# Fact Sheet for NPDES Permit WA002515-1

## Columbia Generating Station

November 1, 2014

After the public comment period closes, EFSEC will summarize substantive comments and provide responses to them. EFSEC will include the summary and responses to comments in this fact sheet as **Appendix E - Response to Comments**, and publish it when issuing the final NPDES permit. EFSEC will not revise the rest of the fact sheet, but the full document will become part of the legal history contained in the facility's permit file.

Artist rendering – from ENW provided design documents:

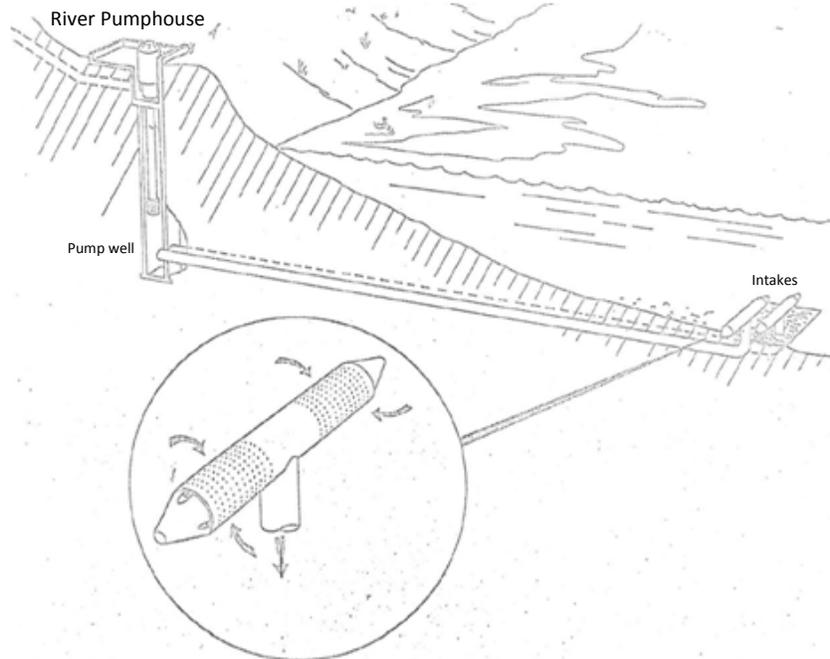
First, an overarching critic in the comments was a perceived lack of data used in EFSEC's analysis of Best Technology Available (BTA). To help remedy this, a fuller description of the existing intakes will be helpful. From the fact sheet:

CGS withdraws water from the Columbia River through two 42-inch diameter inlets perforated with 3/8 inch diameter holes, each approximately 20 feet long and placed parallel to river flow approximately 350 feet offshore at low water. Water flows by gravity to the River Pumphouse.

In evaluating Best Technology Available (BTA), EFSEC considered the design of the CGS intakes as compared to designs considered by EPA in development documents for 316(b) rules. In its comment letter on the draft permit, EPA specifically referred EFSEC to, *Development Document for Best Technology Available for the Location, Design, and Construction, and Capacity of Cooling Water Intake Structures for Minimizing Adverse Environmental Impacts* (EPA, 1976). This document discusses various technologies including “fixed screens” which best fit the technology employed at CGS. It notes that fixed screen installations vary greatly, with effectiveness dependent on site specific design. It also notes:
